# **Return Loss (RL), Effective Return Loss (ERL), and COM Variations**

*For Resolution of Comments 25, 26, 27, & 28*

**IEEE P802.3cd Task Force**

**September 2017**

# Restricting ERL limits COM variability

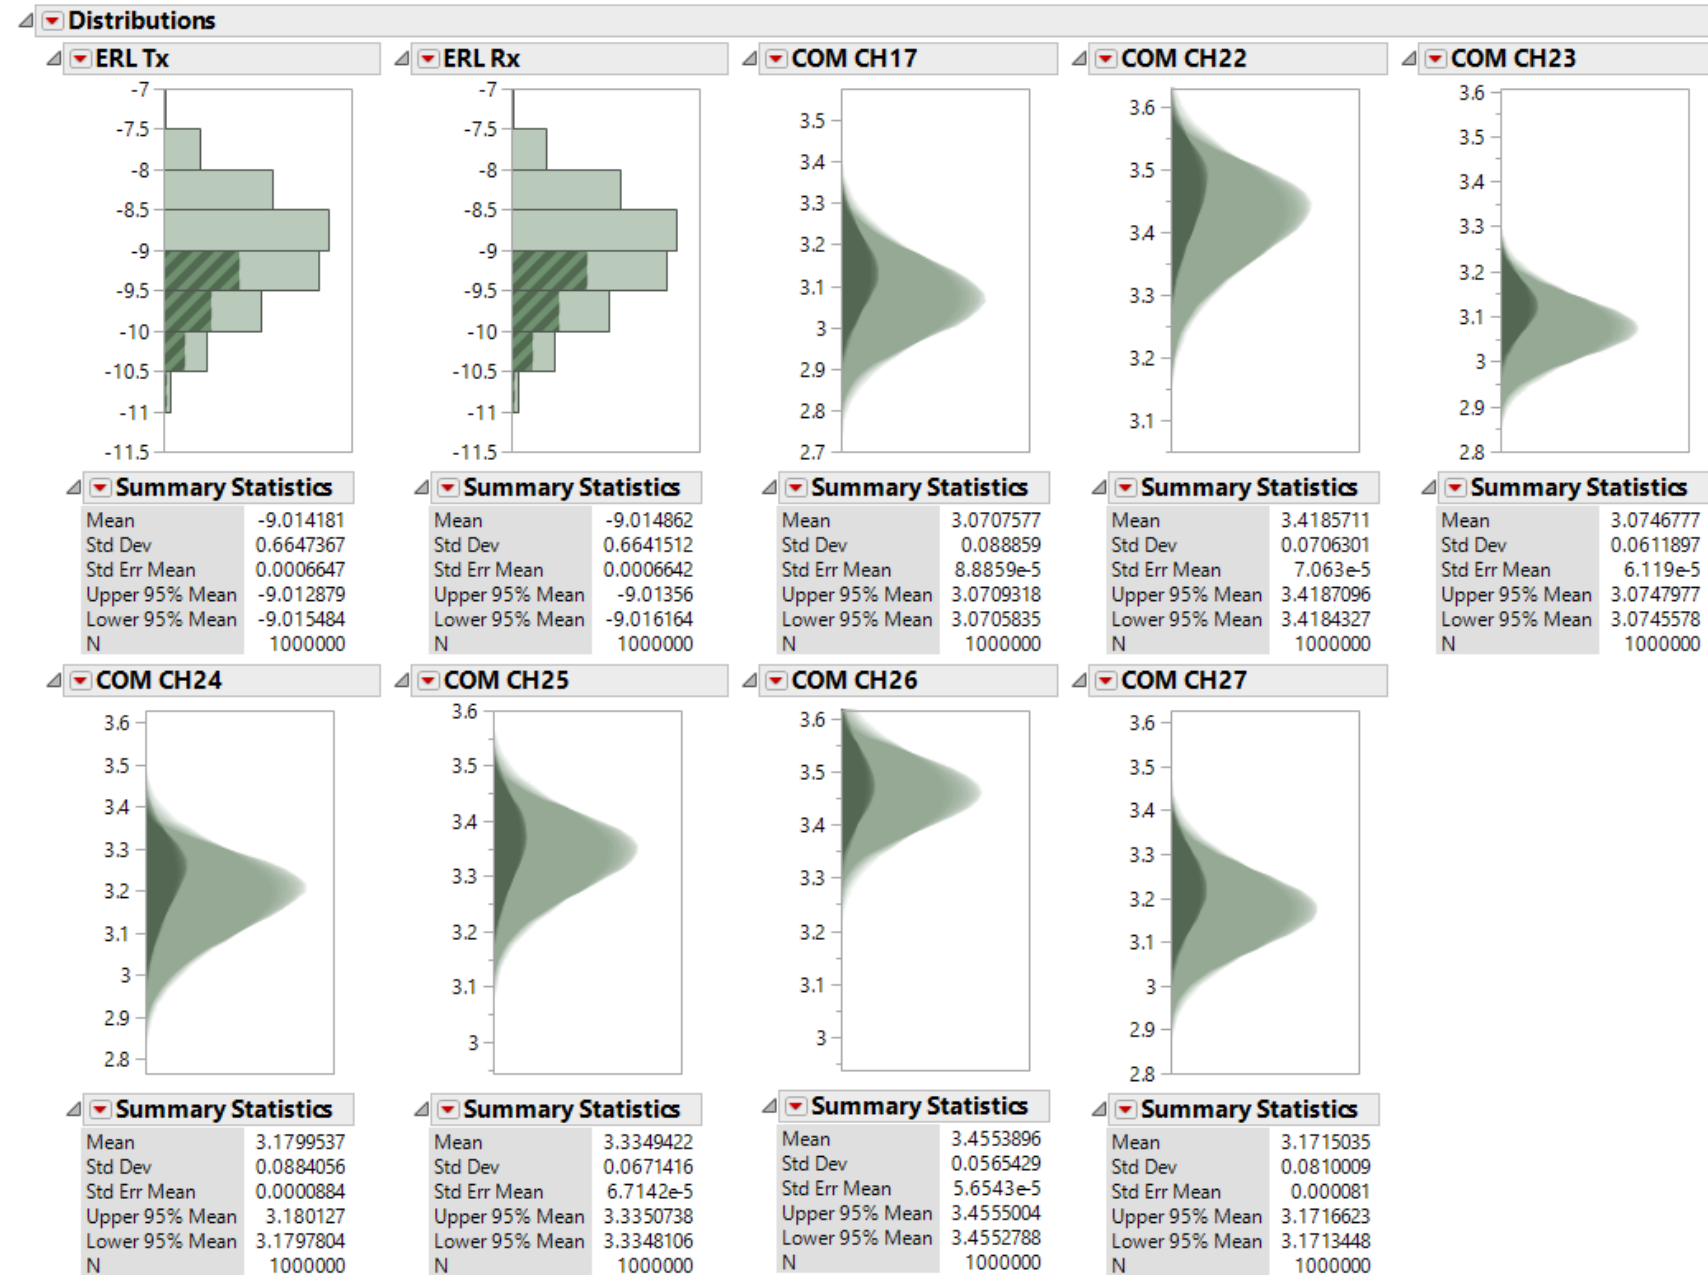
- ❑ The dark green represents cases which use packages with less than -9 dB ERL.
- ❑ But ...

# Now consider shorter packages

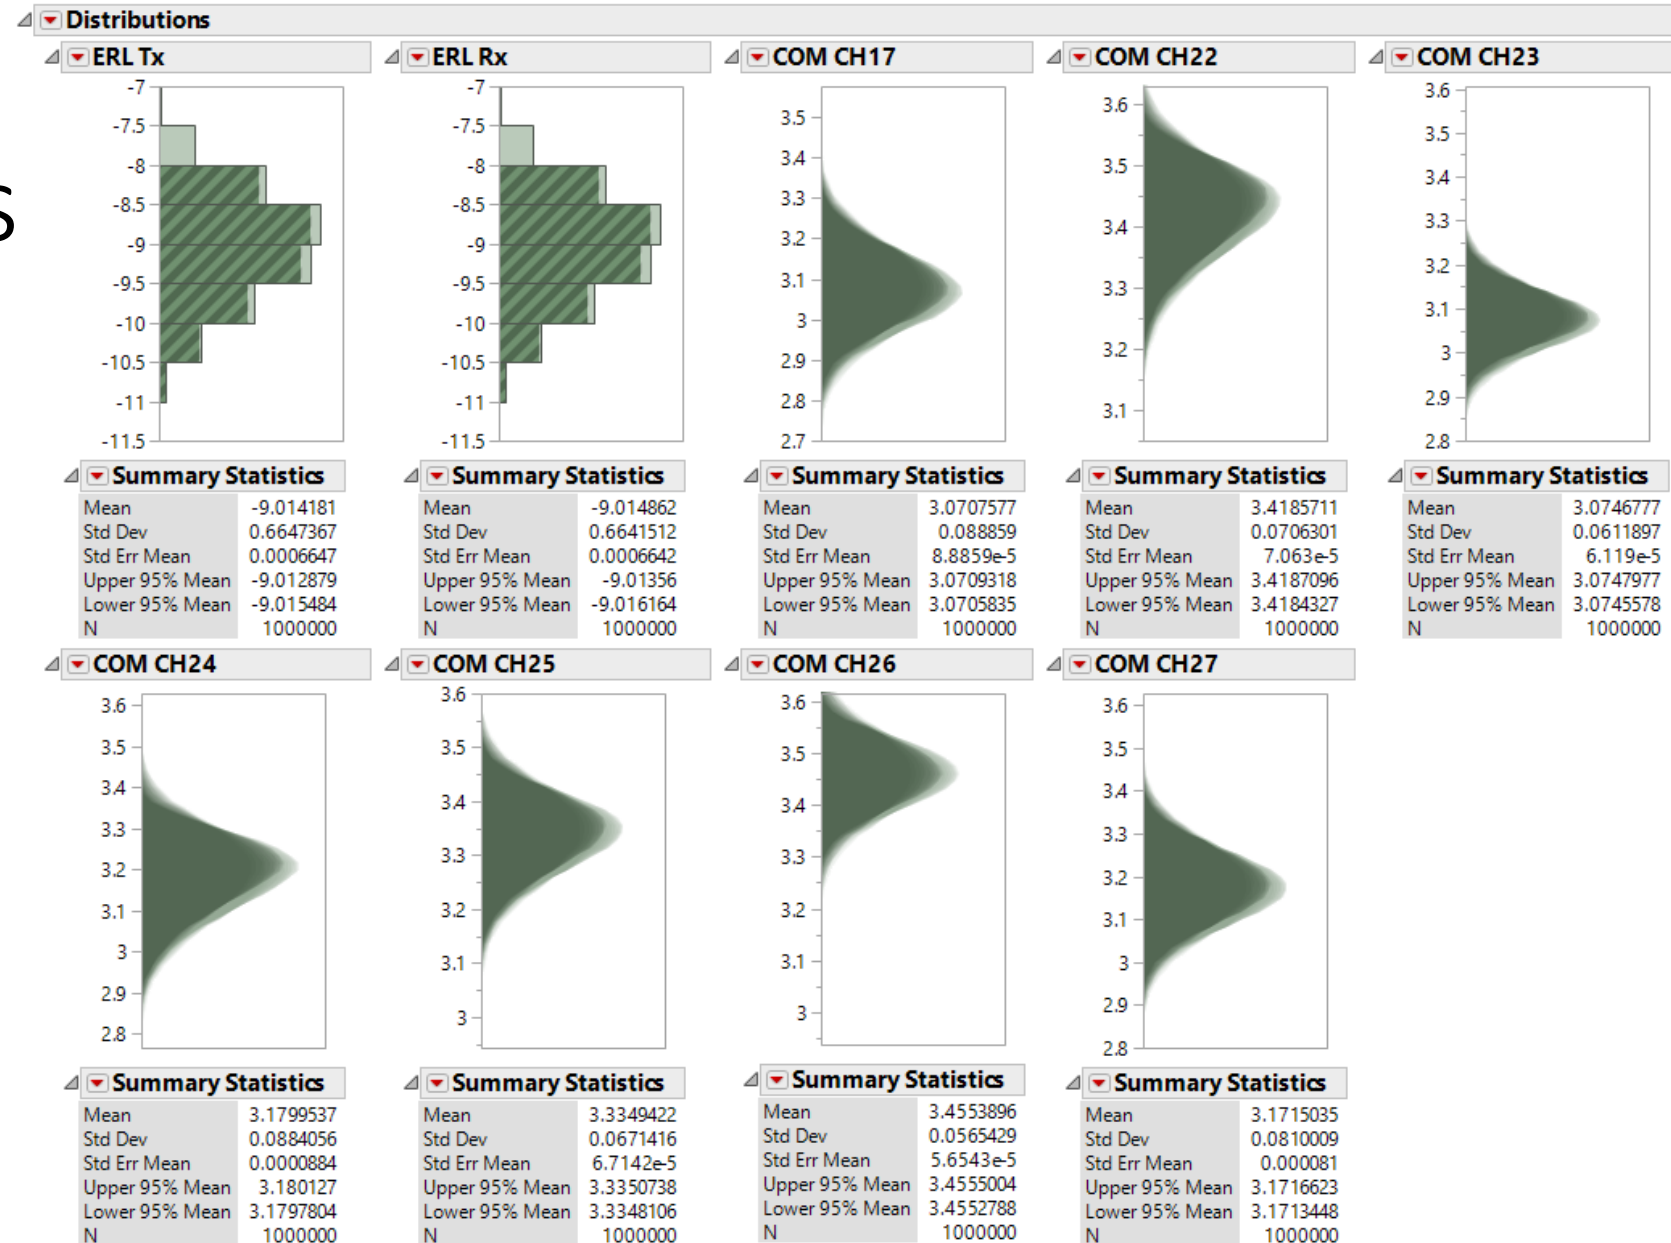
- ❑ Shorter packages have more return loss
- ❑ This might force an ERL limit to be nearly -8 dB
- ❑ The dark green represents cases which use packages with less than -8 dB ERL
- ❑ Little restriction in variability
